CAIRNGORMS NATIONAL PARK AUTHORITY

Title: APPROVAL OF PROPOSED CNPA RESPONSE TO TRANSPORT SCOTLAND INFORMAL CONSULTATION ON THE A9 DUALLING, PROJECT 11 DALRADDY TO SLOCHD

This paper provides an overview of Transport Scotland's proposals for dualling the section of A9 between Dalraddy and Slochd and asks the Committee to endorse the proposed CNPA response to this informal consultation.

Summary of Project 11 Dalraddy to Slochd

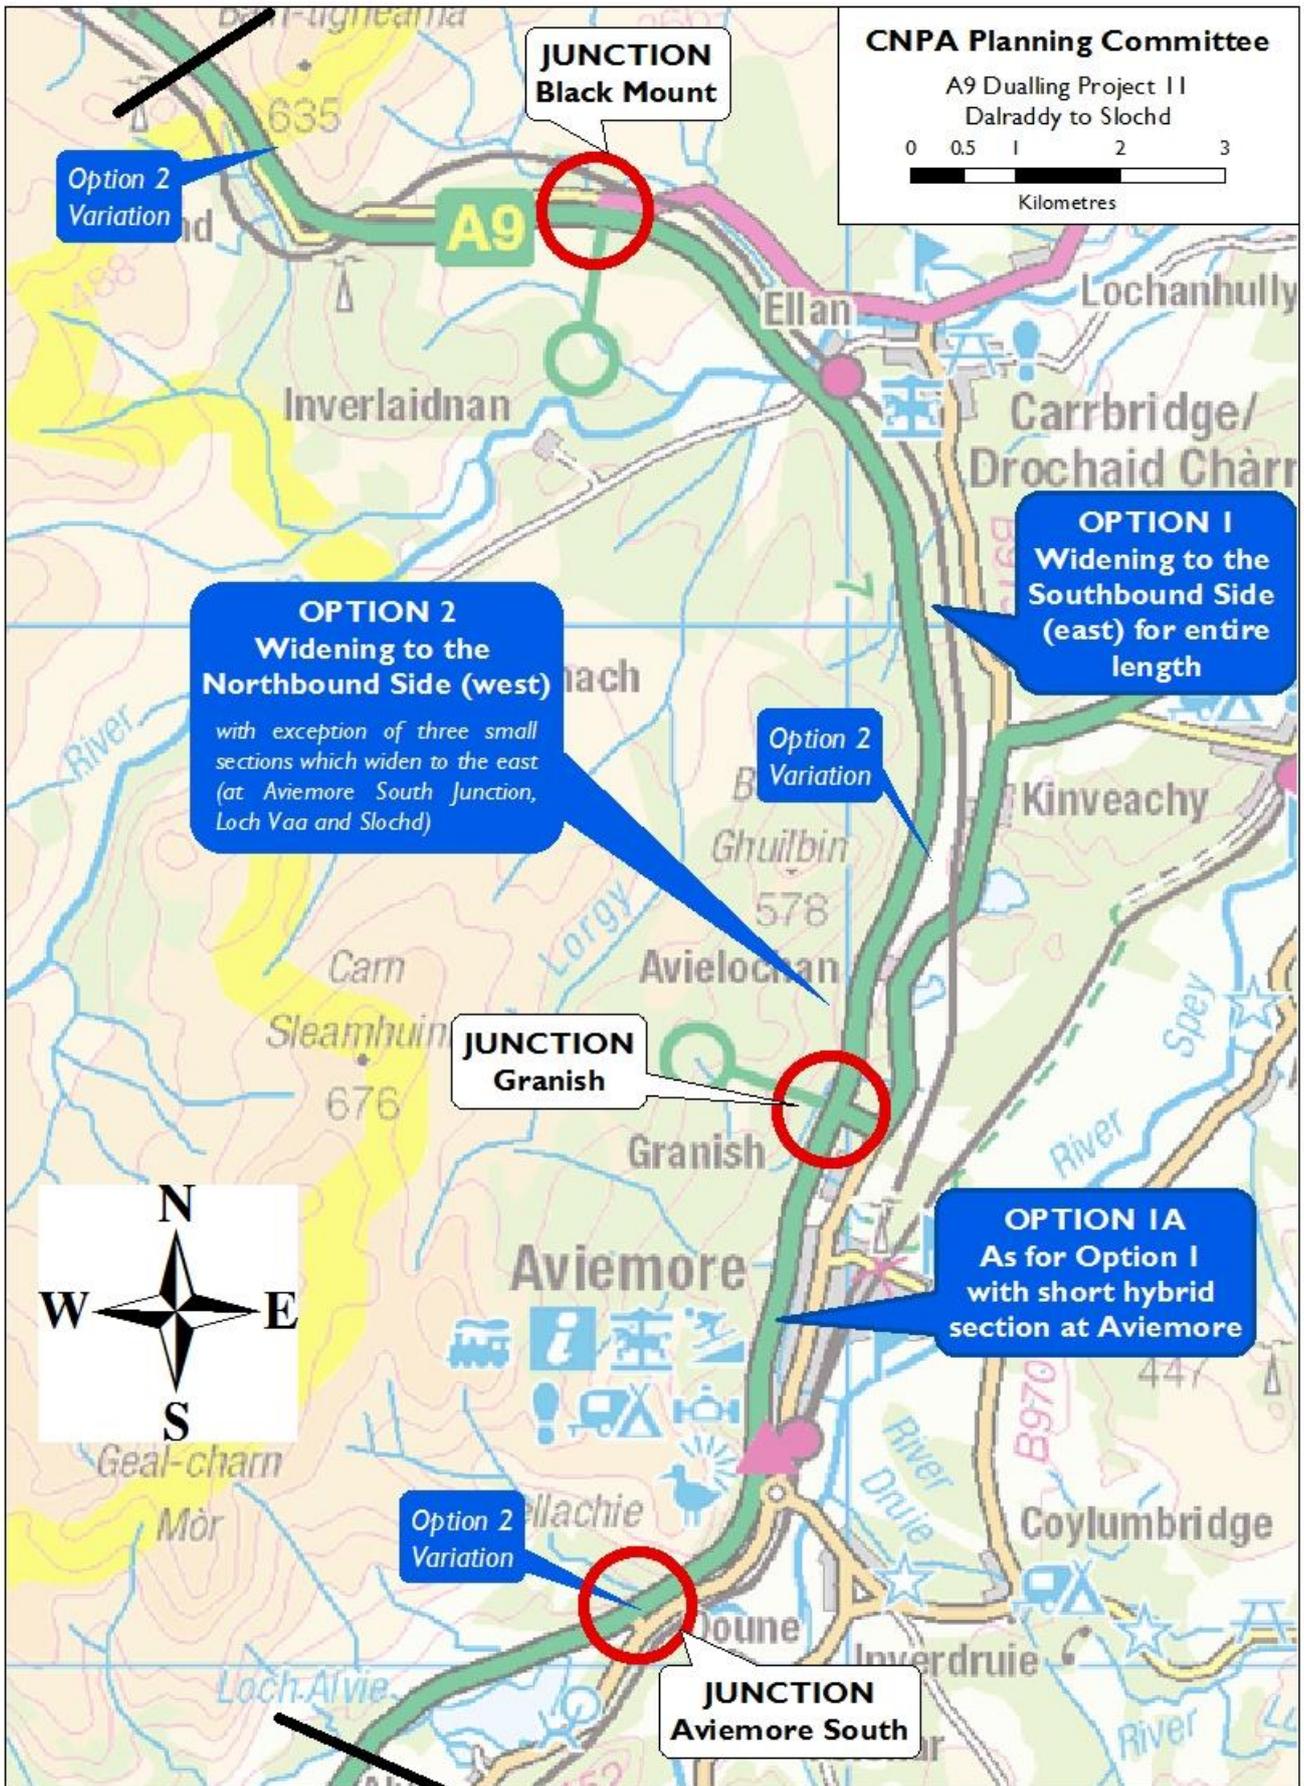
11. This project is structured differently from previous ones. Previous consultations have split the project into multiple sections and then presented options for each of these sections. For this project only 3 options are presented, each one for the entirety of the length of the project:
- i. **Option 1** – Widening to the east (southbound side) for the length of the project
 - ii. **Option 1A** – As for Option 1 but with a small section at Aviemore widening to both sides
 - iii. **Option 2** - Widening to the west (northbound side) for the length of the project with the exception of a short section to the south of Aviemore at the junction location, another near Loch Vaa, and the other at the Slochd where it will widen to the east (southbound side)

12. This project includes three junctions each with a number of options detailed below.
13. **Aviemore South** – all route alignments are the same at this location, widening to the southbound side (east). There are three junction options proposed, each incorporating an 'overbridge' providing access over the A9. One option would result in a slight re-alignment of the B9152. All options are in a similar position to the existing junction.

14. **Granish** (Aviemore North) – four options are proposed, each incorporating an 'underbridge' providing access under the A9. Two of the junction options are compatible with the route alignment which widens to the southbound (east) side and the other two are compatible with the route alignment which widens to the northbound (west) side. All options are in a similar position to the existing junction.

15. **Black Mount** (Carr-Bridge) – six junction options are proposed at this location. Three are compatible with southbound (east) widening and the other three are compatible with the northbound (west) widening. All options incorporate an 'overbridge' providing access over the A9. Two of the options provide for 'restricted movements' only. This would allow traffic travelling from the north on the A9 to turn off at this junction but traffic travelling on the A9 from the south would not be able to turn off. Those coming onto the A9 at this junction from the A938 Carr-Bridge road would be able to turn on to the road and travel northbound but not southbound.

17. In respect of public access and NMU interests no specific comment is made over which of the proposed mainline options are favoured. It is noted that Option I and IA will lead to significant impacts upon the 'Aviemore Orbital' core path (LBS30), however, this is considered to be resolvable through mitigation. Impacts on Craigellachie NNR are most prevalent in respect of Option 2 as are effects on General Wade's Military Road with losses at key sections.

21. This Project will result in some of the most significant changes along the whole of the A9 programme as it goes through the CNP. In particular the excavation for the Slochd and the need to 'thread' it past Aviemore presents many technical difficulties. There is really only one option for the Slochd and the issues are common to all of the options presented.

22. In landscape and ecological terms Option I (widening on the southbound side/to the east) results in the least loss of habitat and landscape features. This is because it requires smaller excavations to the west and therefore less woodland loss on the upslope side. There would be greater filling to the east to support the new carriageway but this presents more opportunities for mitigation planting (this will take some time to be effective) and in places south of Carr-Bridge may even open some views to southbound travellers towards the mountain core. It does, however, build closer to more homes and Aviemore in general and this may offset these advantages depending on the detailing of the final scheme and mitigation planting. There is potential for the loss of existing trees which provide a screen between the road and Aviemore at present.

23. Option IA takes the same alignment as Option I, however, it avoids the properties around Aviemore and minimises the loss of Craigellachie NNR.

24. Option 2 mostly widens on the northbound side (to the west) though not always. There is a greater requirement to excavate along the steep slopes close to the roadside. In places this is quite extensive (in addition to the Slochd). These excavated areas may take a long time to fully revegetate back to woodland. Of particular concern is a large excavation that may impact upon Tor Beag Fort (a Scheduled Monument). This option would also require the loss of parts Craigellachie NNR including Loch Puladdern, which was previously reduced when the current A9 was built in the 1980's. The carriageway would be closer to Highburnside, however, it would occupy space between the road and housing taken by immature landscaping for the development.

26. Option 1 widens to the east and would result in the demolition of 5 residential properties and land take from 1 other. Three of these properties are in Aviemore. Option 1A is the same as Option 1 with the exception of the section passing Aviemore. This alternative option would result in no demolition of properties in Aviemore but would increase the number of properties impacted through land take to 9. Both options would result in land take from commercial properties, community land, agricultural holdings and housing sites. Option 1 and 1A would result in the loss of 24% of a croft holding at Carr-Bridge.

27. Option 2 widens away from Aviemore and therefore has a much lower impact on properties in this area but a much greater impact on the National Nature Reserve at Craigellachie and the public amenity of the site. All options have an impact on properties in Carr-Bridge including houses on Station Road and the currently unused Timber Yard. The consultation report does not accurately assess this impact and this will be noted to Transport Scotland. Option 2 will have a much lower impact on land take at the Croft at Carr-Bridge but will still require land take from several agricultural holdings in this location.

33. All junction options provide for a 'road to nowhere' i.e. the priority of the traffic is to go straight on where in fact no road exists. All traffic must therefore 'turn-off' the access road to enable them to access the slip road rather than simply following the road around to the slip road. It is not clear why this has been done for every junction in this project when it has not been the case for previous projects. This may in some cases enable junctions to provide access for land managers and smaller housing groups as well as delivering a smaller junction foot print. It would have been helpful to have had the reasons for this explained within the consultation report, particularly as it is an issue that has raised concern with communities.

34. Properties on Station Road at Carr-Bridge are not identified as being significantly impacted upon. It would appear, however, that given the proximity of two of these properties to the road on either side they would be significantly impacted and as such the appraisal of impact should be revisited.

35. Slochd Mhor Lodge is noted as a holiday let only (Hostel/Bunk House) but the value of the property as a wider activity attraction has been omitted. Slochd Mhor Lodge also operates an activity business providing bike trails, ski trails and bike shop. The impact on this business of the loss of the Slochd junction and the potential implications of a restricted access junction at Black Mount needs to be revisited and impacts assessed accordingly.

- i) rock cuts at Slochd and other places will be very significant in this section and particular attention to the design of these is required. In particular the drama and very strong sense of place that the Slochd exhibits should be recreated by keeping cut faces as steep and as close to the road as safely possible but without the need for netting;

- k) mitigation in the area below the A9 may be particularly effective if current natural landforms and tree growth patterns are replicated.
